ADDENDUM NO. 1

**Water & Wastewater Improvements
Graham Cave State Park
Danville, Missouri
Project No. X2321-01**

Bidders are hereby informed that the construction Plans and/or Specifications are modified as follows:

G-002

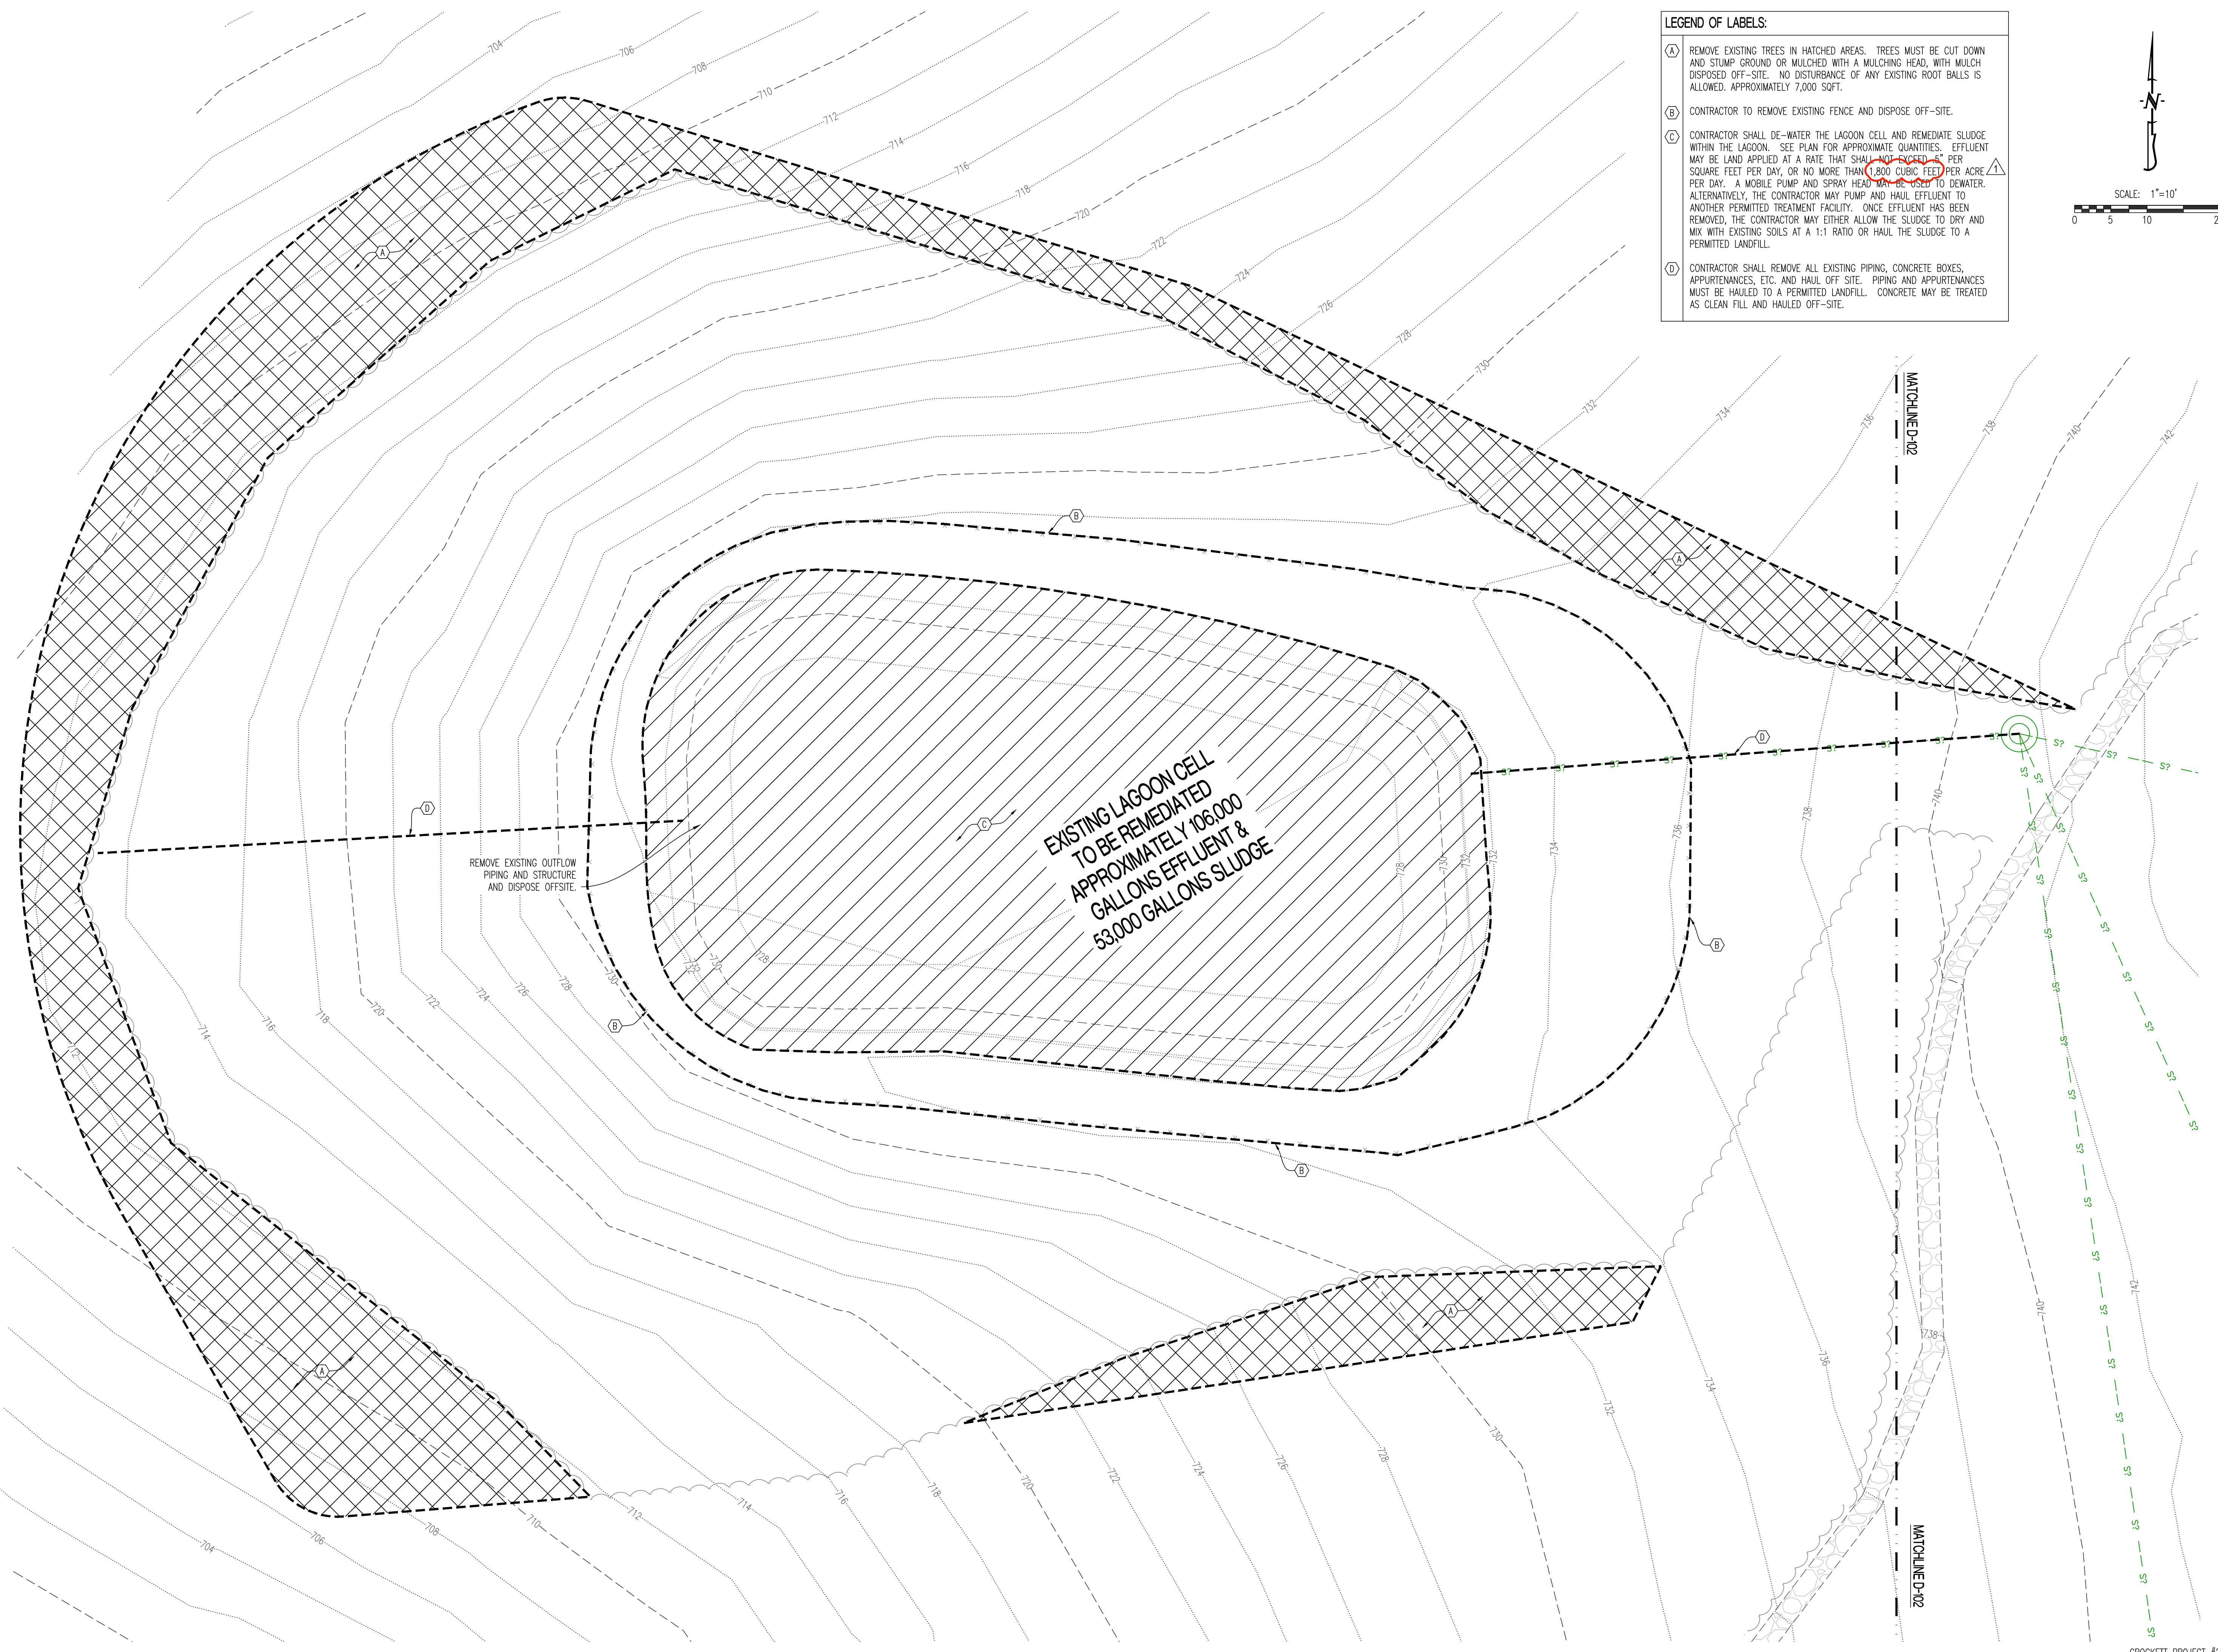
1. Sheet G-002
 - a. Note added showing location on site where effluent disposal is permitted.
 - b. See attached revised drawing.
2. Sheet D-101
 - a. REVISE Key Note C to show that 1,800 cubic feet per acre of effluent disposal is permitted.

NOTE: IN CONSULTATION WITH PARK STAFF THE SHADED 12.5 ACRE NATIVE GRASS AREA MAY BE USED AS AN EFFLUENT DISPOSAL AREA WITH A MOBILE TANK TRUNK AND SPRAYER. EFFLUENT APPLICATION RATE MAY NOT EXCEED 0.5" PER SQUARE FEET PER DAY OR NO MORE THAN 1,800 CUBIC FEET PER ACRE PER DAY. (13,500 GALLONS PER ACRE PER DAY)

D-103

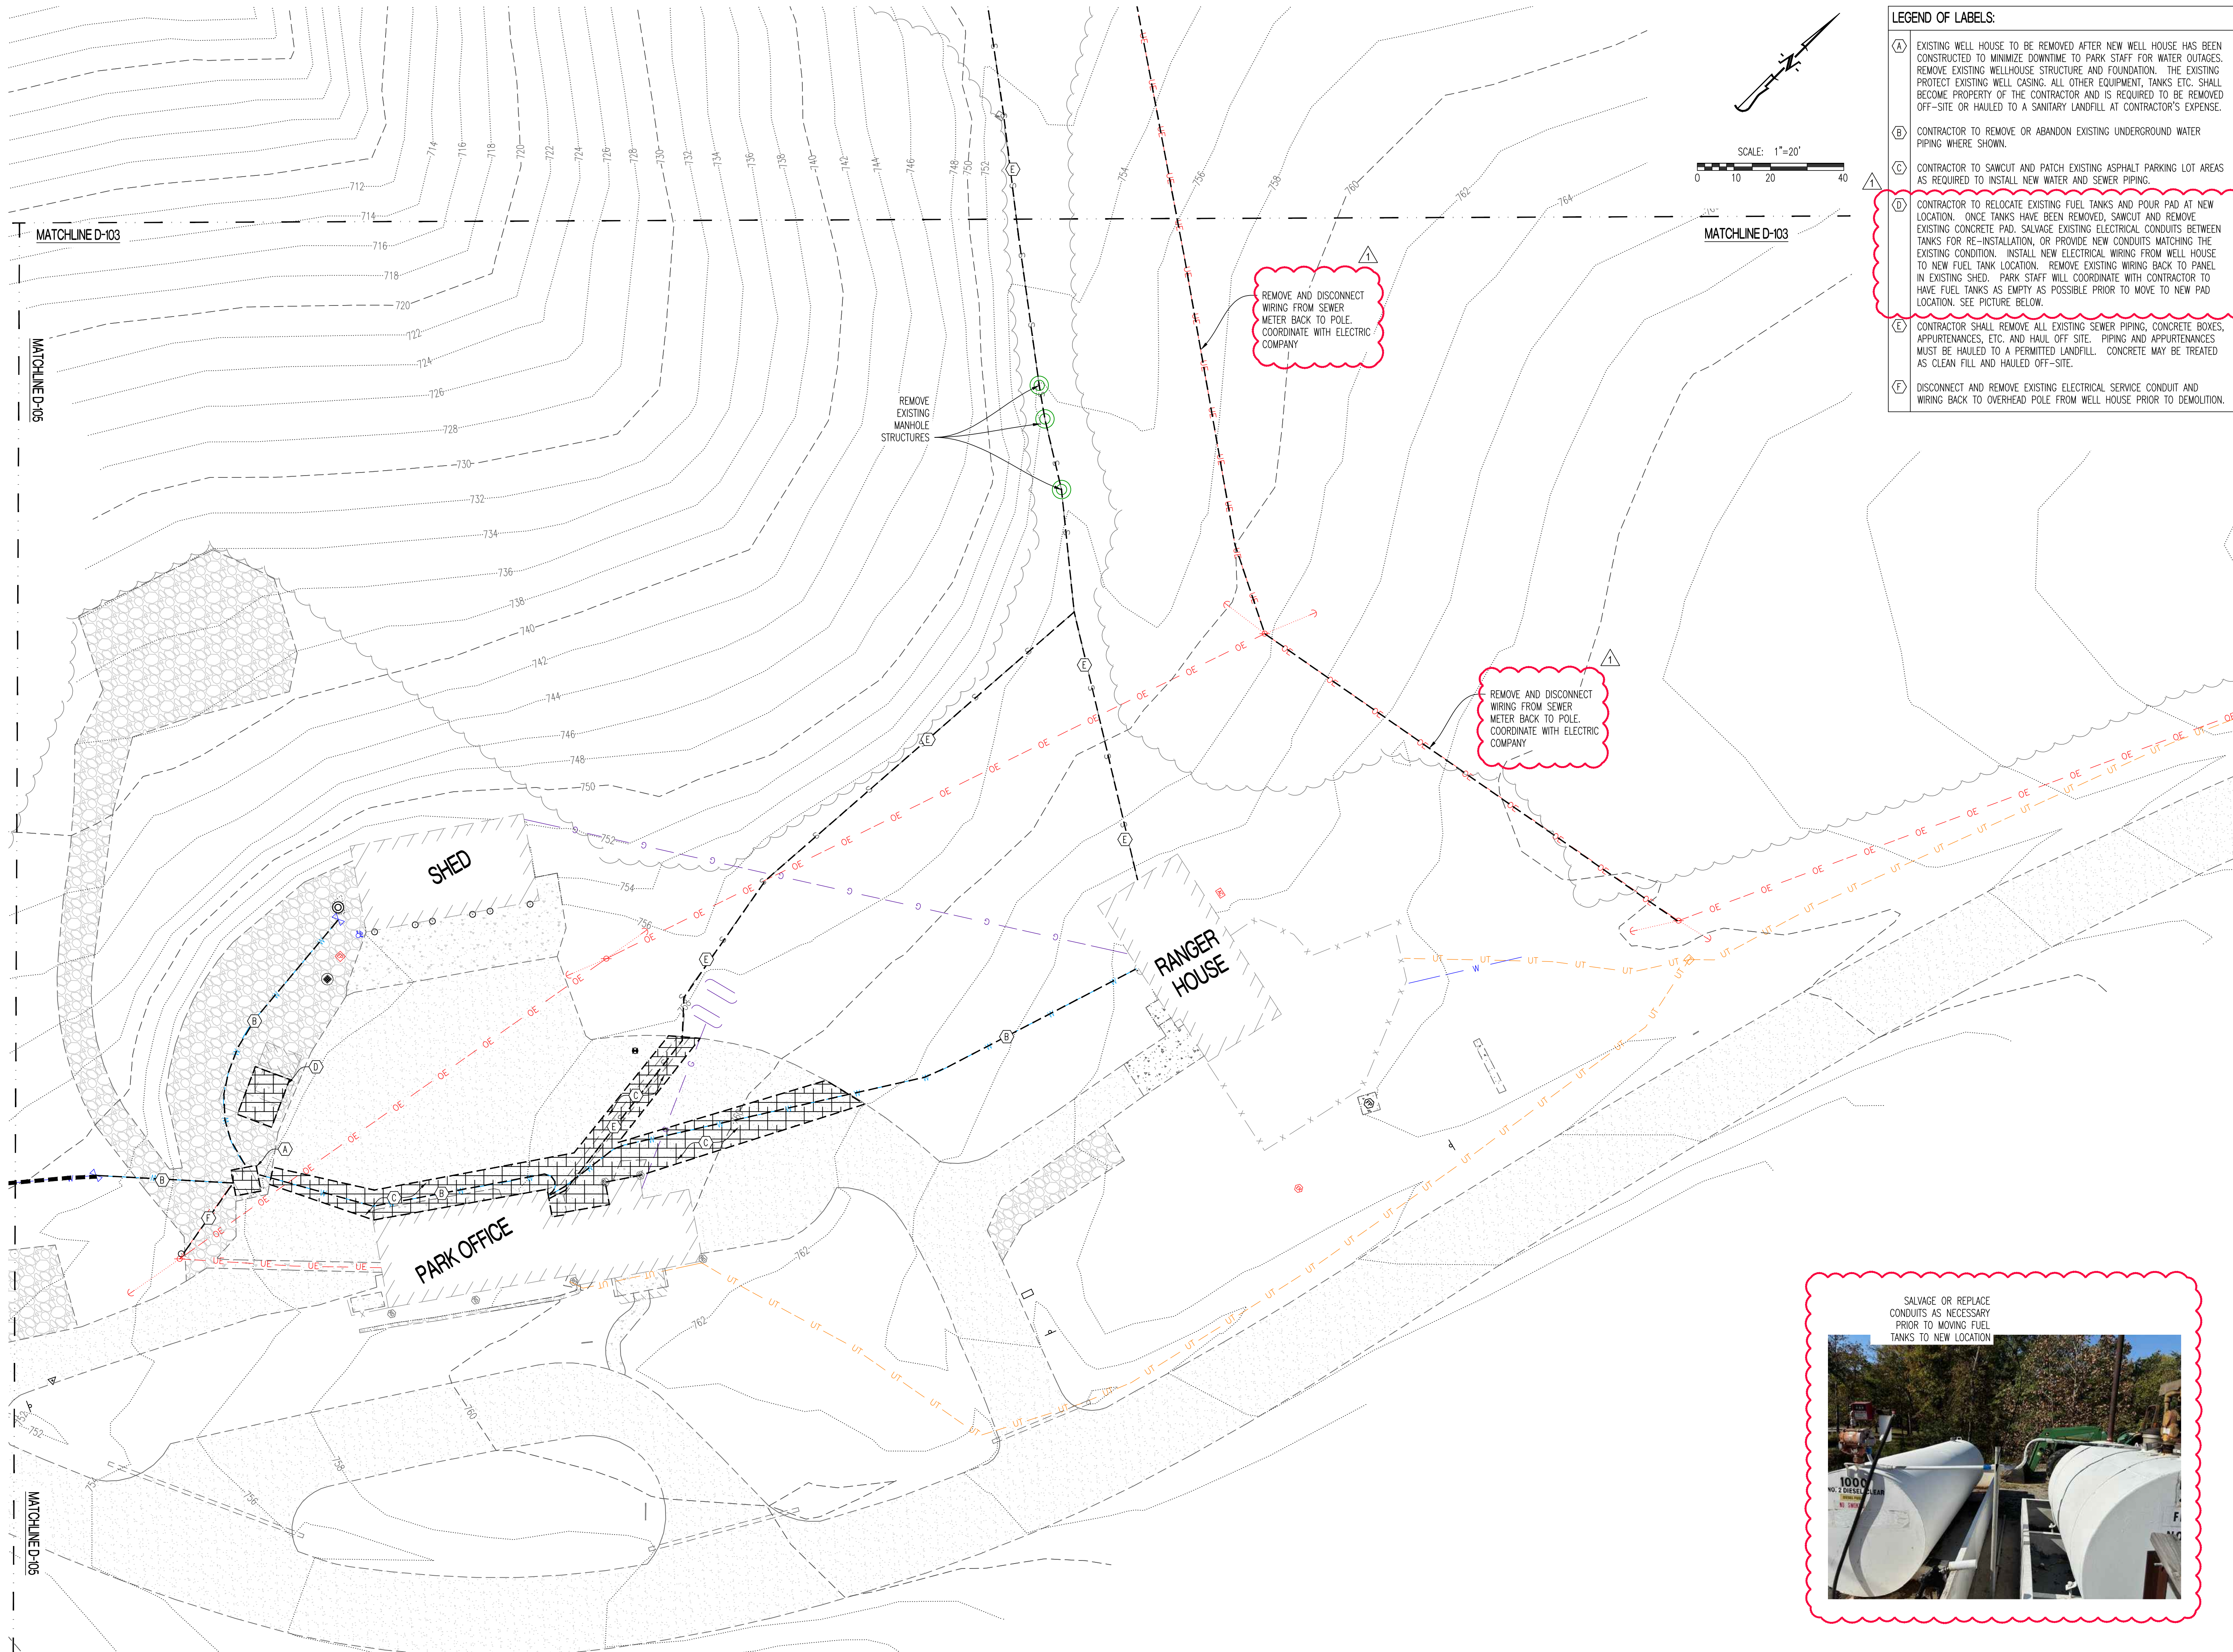
- b. See attached revised drawing.
3. Sheet D-103
 - a. REVISE Key Note C to show that 1,800 cubic feet per acre of effluent disposal is permitted.
 - b. See attached revised drawing.

- (B) CONTRACTOR TO REMOVE EXISTING FENCE AND DISPOSE OFF-SITE.
 - (C) CONTRACTOR SHALL DE-WATER THE LAGOON CELL AND REMEDIATE SLUDGE WITHIN THE LAGOON. SEE PLAN FOR APPROXIMATE QUANTITIES. EFFLUENT MAY BE LAND APPLIED AT A RATE THAT SHALL NOT EXCEED 800 CUBIC FEET PER ACRE PER DAY, OR NO MORE THAN 800 CUBIC FEET PER ACRE PER DAY. A MOBILE PUMP AND SPRAY HEAD MAY BE USED TO DEWATER. ALTERNATIVELY, THE CONTRACTOR MAY PUMP AND HAUL EFFLUENT TO ANOTHER PERMITTED TREATMENT FACILITY. ONCE EFFLUENT HAS BEEN REMOVED, THE CONTRACTOR MAY EITHER ALLOW THE SLUDGE TO DRY AND MIX WITH EXISTING SOILS AT A 1:1 RATIO OR HAUL THE SLUDGE TO A PERMITTED LANDFILL.
